METROPOLITAN GOVERNMENT OF NASHVILLE AND DAVIDSON COUNTY

STAFF RECOMMENDATION
3747 Whitland Avenue
April 16, 2014

Application: New construction—addition
District: Whitland Neighborhood Conservation Zoning Overlay
Council District: 24
Map and Parcel Number: 10409020900
Applicant: Kristin Harney
Project Lead: Melissa Baldock, melissa.baldock@nashville.gov

<p>Description of Project: Application is to construct a side addition for an elevator.</p> <p>Recommendation Summary: Staff recommends approval of the project with the condition that the staff approve a stone sample for the foundation. With this condition, staff finds that the project meets Section II.B. of the <i>Whitland Neighborhood Conservation Zoning Overlay: Handbook and Design Guidelines</i>.</p>	<p>Attachments A: Photographs B: Site Plan C: Elevations</p>
---	--

Figure 1. 3747 Whitland Avenue

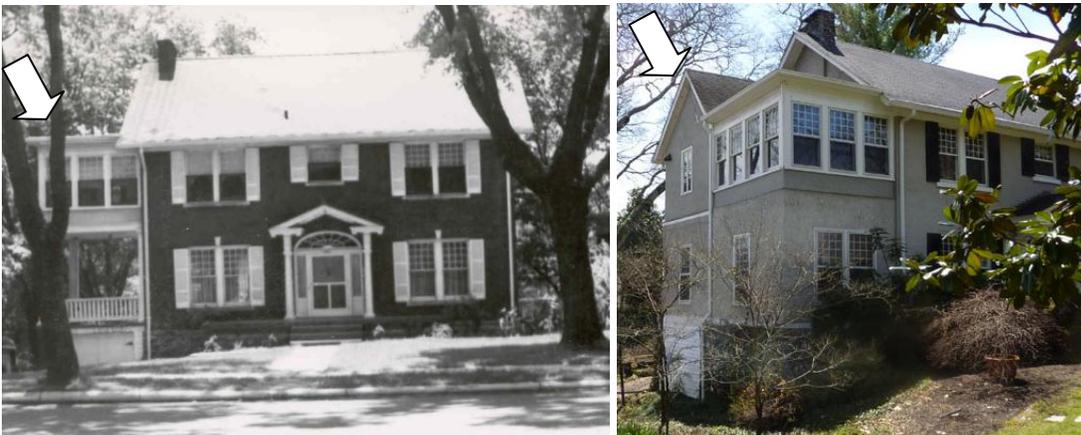
Background: 3747 Whitland Avenue is a two-story Colonial Revival house constructed c. 1935 (Figure 1). The house's former two-story side porch, which appears in a photo from 1956, has been enclosed (Figure 2). A side addition behind the two-story porch was constructed c. 1980 (Figure 3).

The design guidelines also state that *“The addition should set back from the face of the historic structure...”* In this case, the addition will be set back four feet (4') from the front of the enclosed side porch. One of the second-story side windows which appear in the 1950s photo will be retained, while the other three windows will be removed for the side addition. These three windows will be reused on the addition. The addition will require the removal of approximately fifteen feet, three (15'3") of the house's left side façade. Of this, approximately ten feet, six inches (10'6") will be removed from the enclosed side porch. Because the entirety of the front façade of the enclosed side porch, and a portion of its side façade will be retained, staff finds that the proposed addition will not significantly alter the historic character of the side porch, which has already been greatly altered, or the historic house. In addition, staff finds that the addition could be removed in the future and the remaining portion of the side façade could be restored. Staff therefore finds that the project meets Sections II.B.2.a and d. of the design guidelines.

SITE PLAN

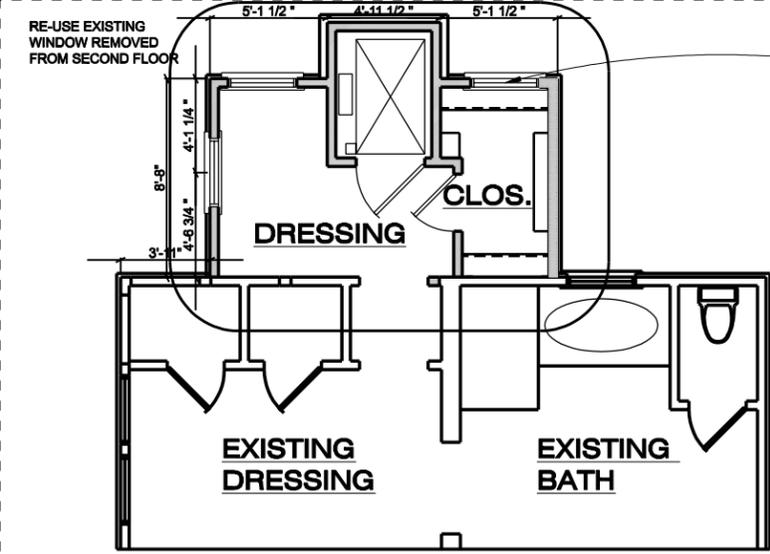
Setback & Rhythm of Spacing: The addition meets the base zoning setbacks. It will be over sixteen feet (16') from the left property line. Staff finds that the project meets sections II.B.1.c. and II.B.2. of the design guidelines.

FLOOR PLANS - NEW CONSTRUCTION

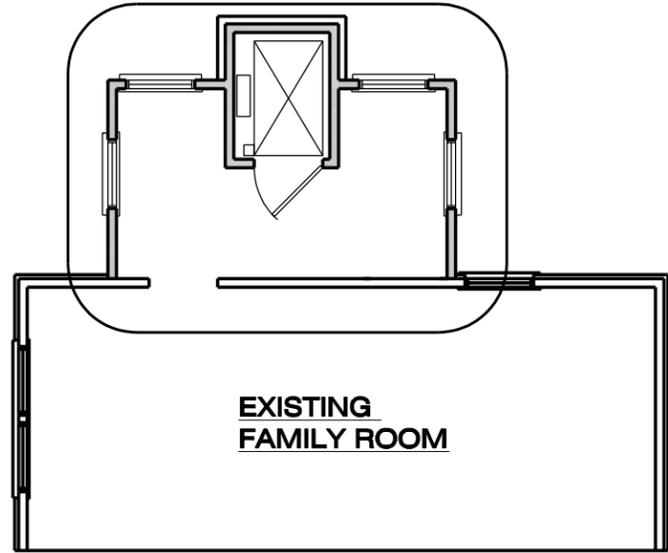
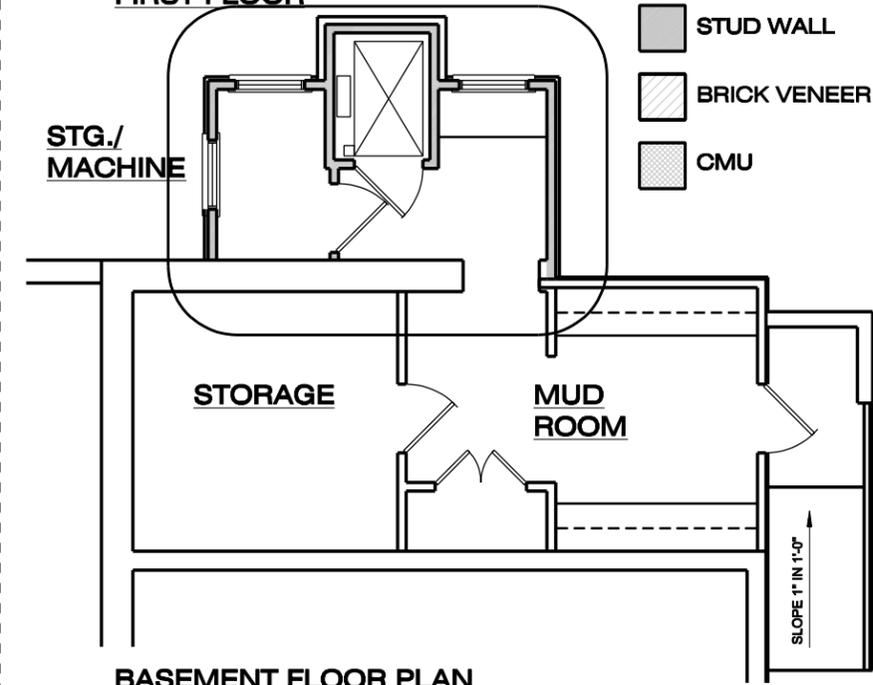
Materials: No changes to the historic house's materials were indicated on the drawings. The addition's materials will largely match those of the enclosed side porch and the side addition. The addition will primarily be clad in stucco, painted to match the side porch and current addition's stucco. The trim will be wood. The foundation will be stone, and staff asks to approve a stone sample. The applicant plans to reuse the three wood windows that will be removed from the second story of the enclosed side porch. The other new windows will be Marvin wood double-hung windows, which are appropriate. Since the roof will be flat, this material will not be visible from the street. Staff finds that the known materials meet sections II.B.1.d and II.B.2. of the design guidelines.

Roof form: The addition will have a flat roof to match the flat roof of the enclosed side porch. Staff finds that the roof form meets sections II.B.1.e. and II.B.2. of the design guidelines.

Proportion and Rhythm of Openings: Other than the removal of the three window openings on the side of the enclosed side porch, no changes to the window and door openings on the existing house were indicated on the plans. The windows on the proposed addition are all generally twice as tall as they are wide, thereby meeting the historic proportions of openings. There are no large expanses of wall space without a window or door opening. The fenestration pattern generally matches the existing pattern of the enclosed side porch, which is appropriate. Staff finds the project's proportion and rhythm of openings to meet sections II.B.1.g. and II.B.2. of the design guidelines.

Recommendation Summary: Staff recommends approval of the project with the condition that the staff approve a stone sample for the foundation. With this condition, staff finds that the project meets Section II.B. of the *Whitland Neighborhood Conservation Zoning Overlay: Handbook and Design Guidelines*.
